ADDENDUM NO. 1

**HANOVER COMMUNITY SCHOOL CORPORATION - NEW RESOURCE
CENTER AND RELATED WORK
Cedar Lake, IN 46303**

This Addendum consists of page ADD 1-1 and attached Addendum No. 1 from Gibraltar Design dated May 27, 2021 and consisting of 5 pages and 48 drawings.

MECHANICS BUILDING - STRUCTURAL FOUNDATION PLAN
SCALE: 1/8" = 1'-0"

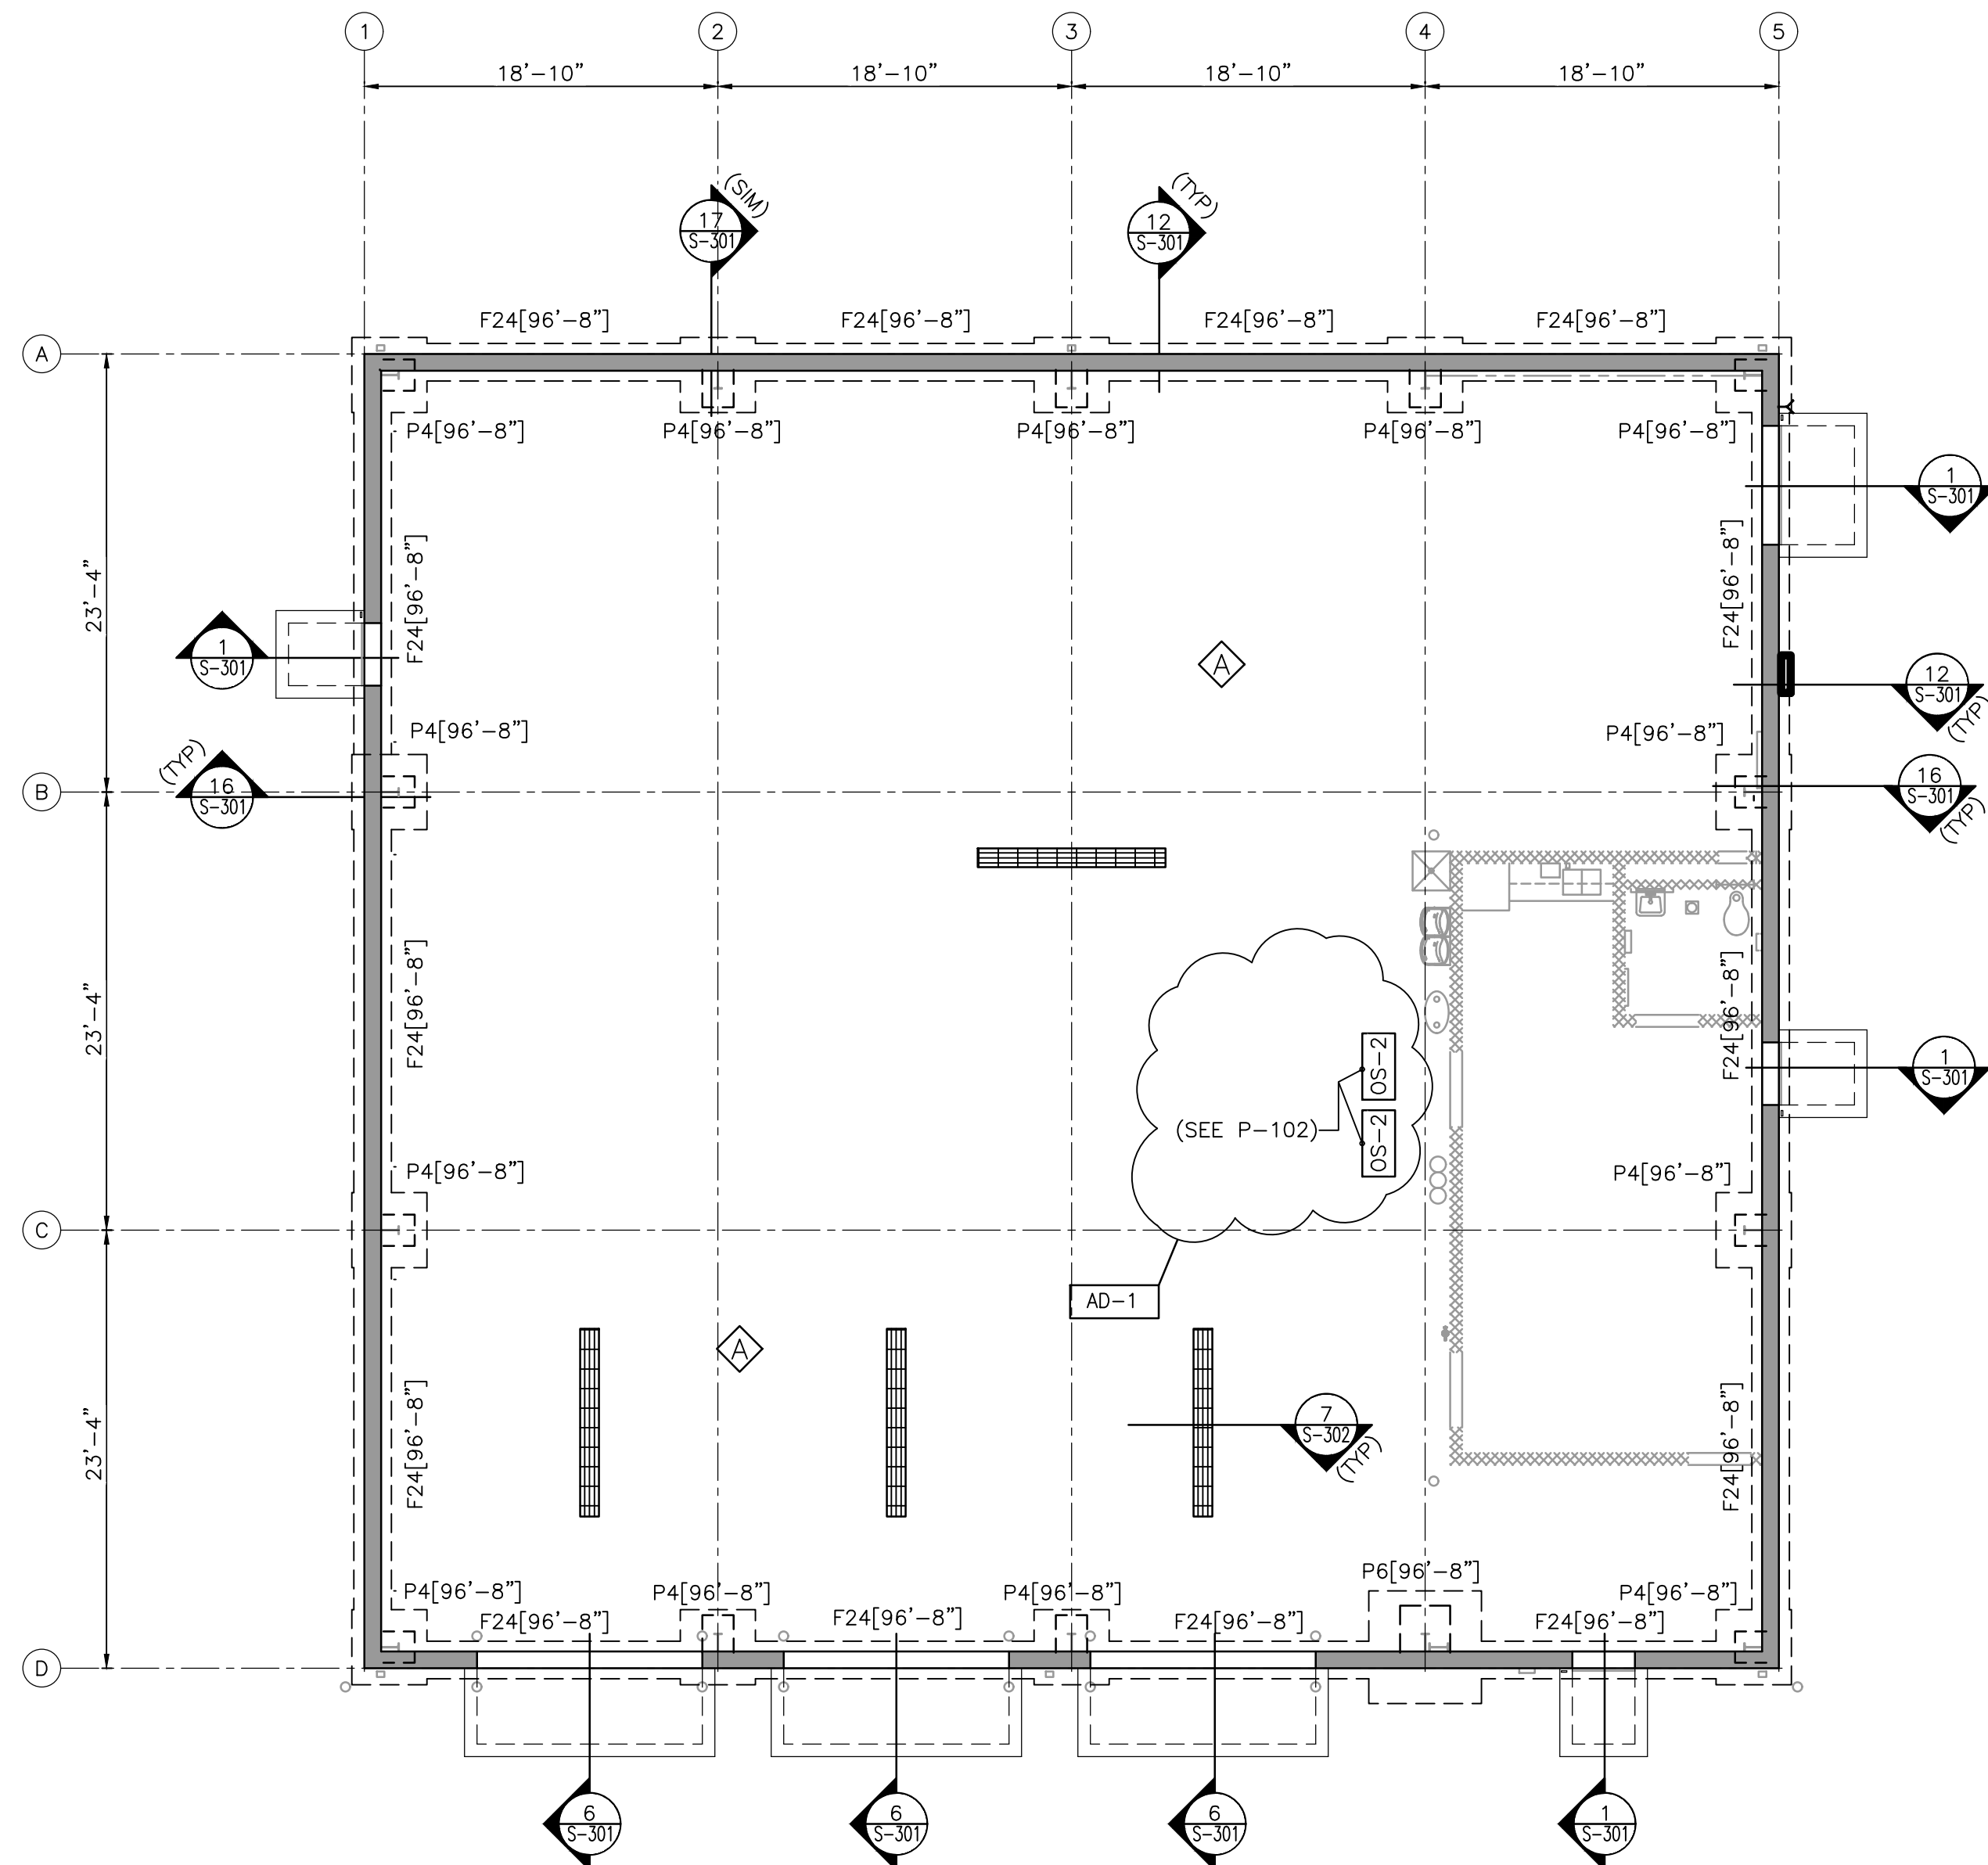
1. Floor drain section cuts revised to be coordinated with plumbing plans.
2. Add oil separator floor pit to the slab plan and coordinate with adjacent footing depths by verifying size with plumbing plans.
3. Add mechanical equipment exterior concrete support pads.
4. On SB101 only, revise section cut 16B/S-301 near Grid A-3 to 17/S-301.
